February 2021 BAR Decision

BAR 21-01-05 116 West Jefferson Street Tax Parcel 330183000 Jefferson Street Properties, LLC, Owner Gordon Johnson, Peter Johnson Builders, Applicant Porch reconstruction

CITY OF CHARLOTTESVILLE BOARD OF ARCHITECTURAL REVIEW STAFF REPORT February 17, 2021

BAR 21-01-06 116 West Jefferson Street, TMP 330183000 North Downtown ADC District Owner: Jefferson Street Properties, LLC Applicant: Gordon Johnson, Peter Johnson Builders Project: Front porch reconstruction, alterations at rear elevation

Existing cornice at 116 West Jefferson Street. New porch cornice to match.

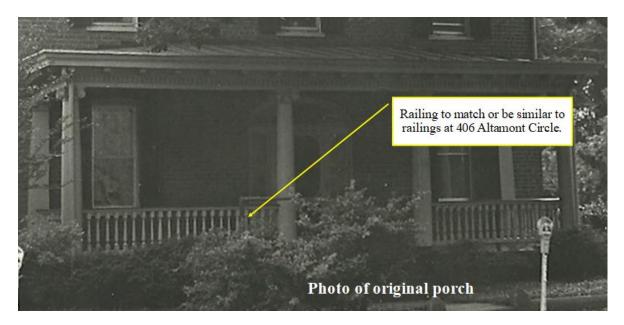
Staff recommends elevation porch roofline and using standing-seam metal in lieu of EPDM. BAR should discuss height relative to window sills.

Ceiling at rear porch (upper) - 116 West Jefferson St.

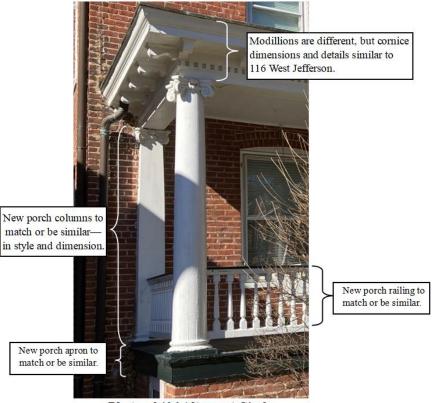
- <u>Ceiling</u>: Beaded-board with simple cove or crown at entablature, similar to existing celling at rear, upper porch. Porch ceiling will be above—and encroach onto--the brick arches above the entry and two windows. Painted. Color: TBD. *
